CAP MEETING – 10 NOVEMBER 2021
ITEM 9.2

DEVELOPMENT NO.:	21019844
APPLICANT:	Bird in Hand Winery
ADDRESS:	150 PFEIFFER RD WOODSIDE SA 5244
NATURE OF DEVELOPMENT:	Variation to 18/828/473 to increase the floor area and the height of the cellar door, restaurant & function facility and internal alteration
ZONING INFORMATION:	Zones: <ul style="list-style-type: none"> • Productive Rural Landscape Overlays: <ul style="list-style-type: none"> • Environment and Food Production Area • Hazards (Bushfire - Medium Risk) • Heritage Adjacency • Hazards (Flooding - Evidence Required) • Limited Land Division • Mount Lofty Ranges Water Supply Catchment (Area 2) • Native Vegetation • Prescribed Water Resources Area • Water Resources
LODGEMENT DATE:	29 Jul 2021
RELEVANT AUTHORITY:	Assessment Panel at Adelaide Hills Council
PLANNING & DESIGN CODE VERSION:	2021.10
CATEGORY OF DEVELOPMENT:	Code Assessed - Performance Assessed
NOTIFICATION:	Yes
RECOMMENDING OFFICER:	Doug Samardzija Statutory Planner

- Increase the height of the building from 15.24m to 18m, an increase in height by 2.76m
- Increase the floor area by 150m², which includes a combined increase in the ground floor and first floor areas

First Floor/Gallery

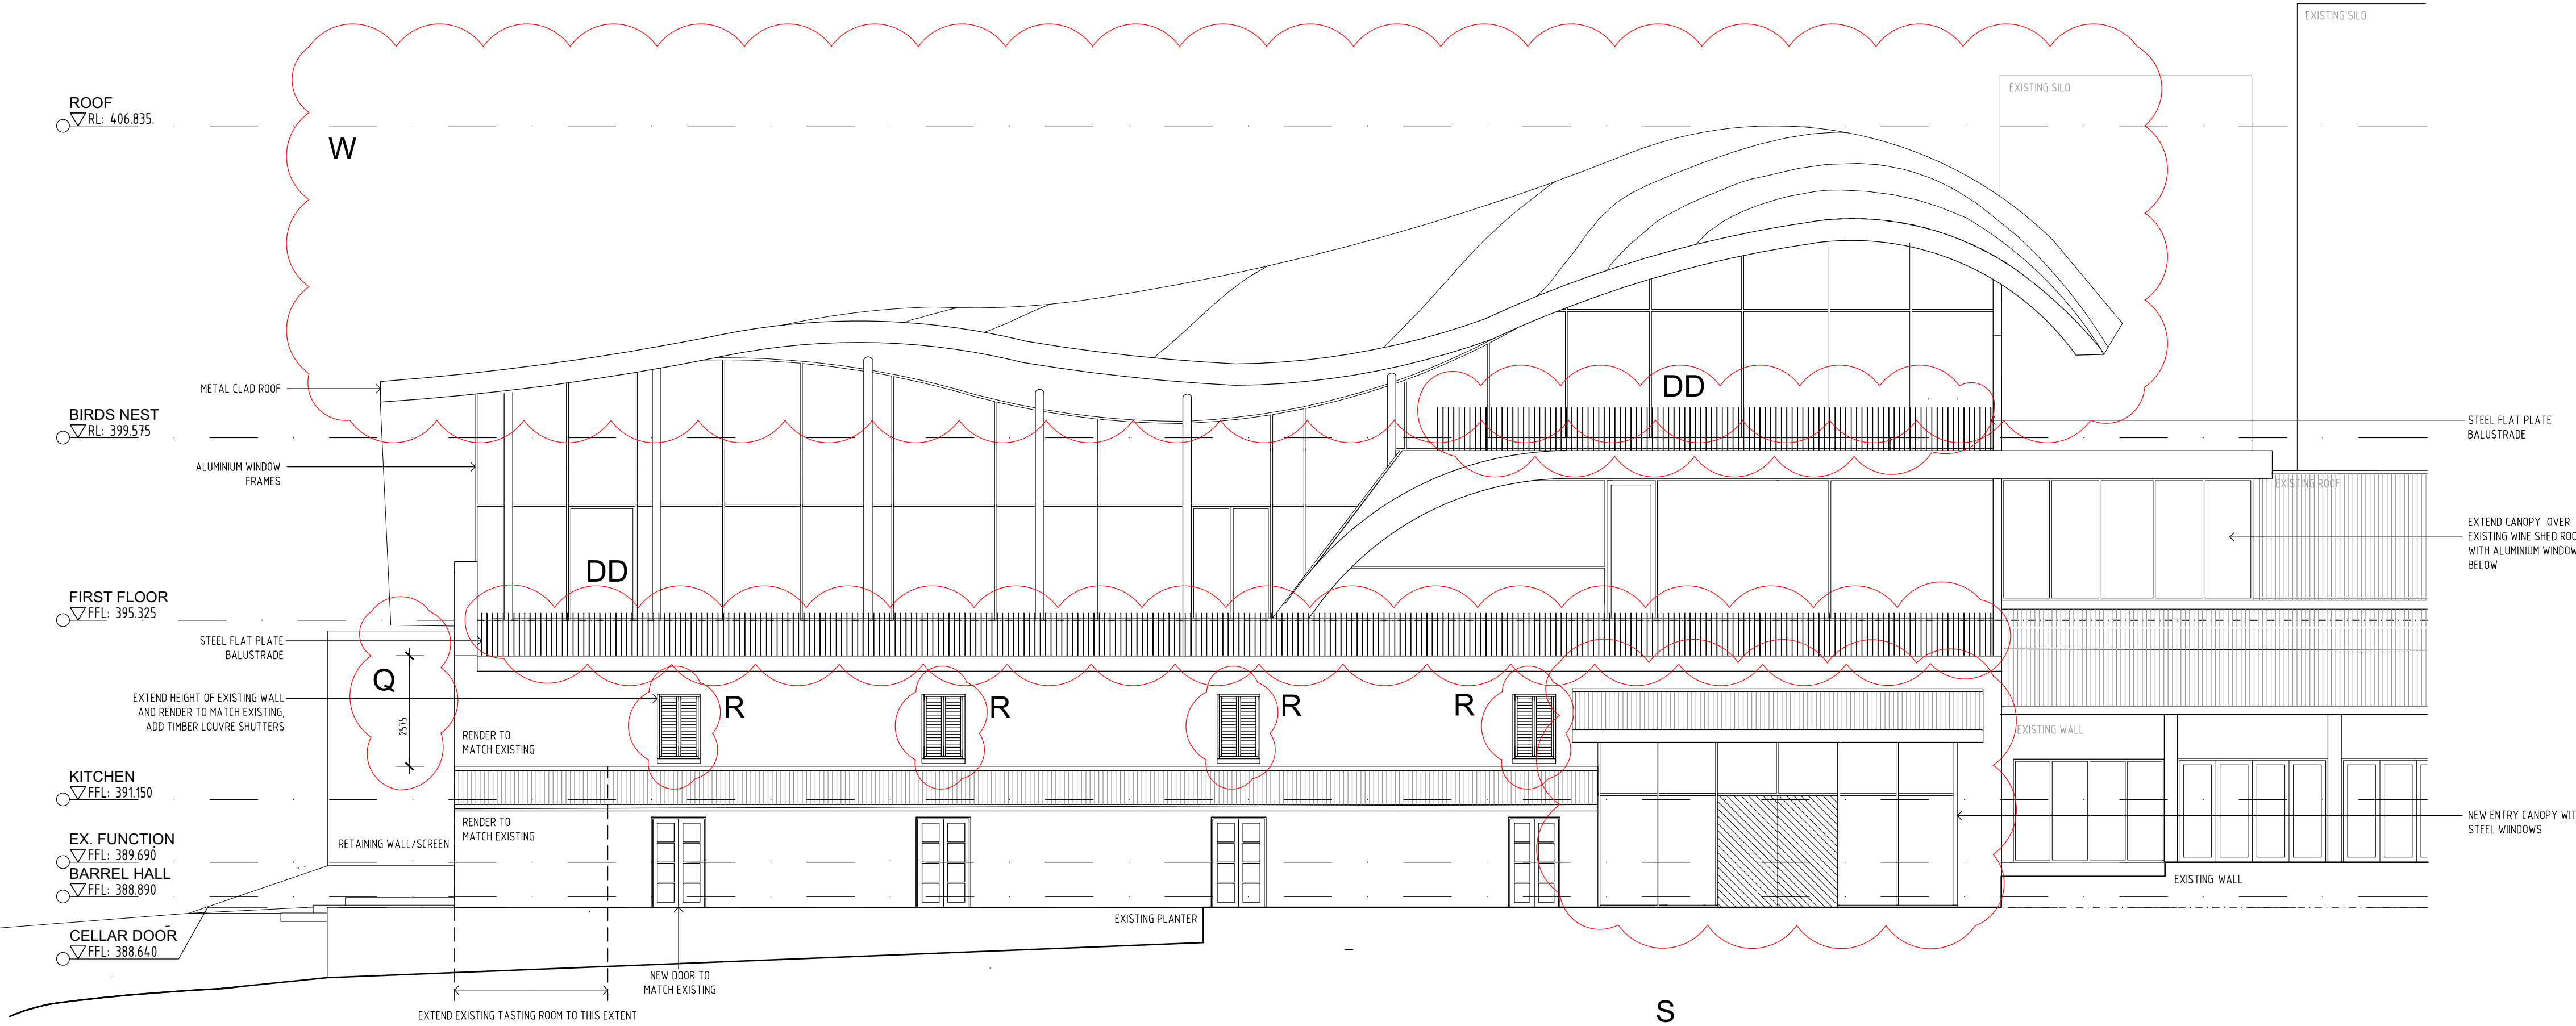
- The Basement/Cellar*
- (a) location of the "everyday access stair" moved to north eastern corner (no personal lift access to this level);
 - (b) vehicle lift added;

- (c) work/store room created;
 - (d) length of the floor level increased in length in an easterly direction by 3145 mm;
 - (e) 4000 mm high vaulted arched distressed plaster ceiling and columns;

- (i) length of the tasting room and barrel hall increased in length in an easterly direction by 3145 mm;
- (j) barrel hall floor height increased by 250 mm (requiring 2 steps down to tasting room and main entry)

- (k) the eastern side of the barrel hall feature door increased in height and external steps and ramp reconfigured to suit;
- (l) vehicle lift added;
- (m) location of the everyday access stair position changed;

- (t) length of the floor level increased in length in an easterly direction by 3145 mm;
- (u) location of the everyday access stair position changed;
- (v) fire stair added to southern wall;
- (w) overall roof height increased to RL 406.835;
- (x) southern wall is to be rendered to match the existing wall;
- (y) stair case up to mezzanine floor relocated to the on southern wall with curving roof above;
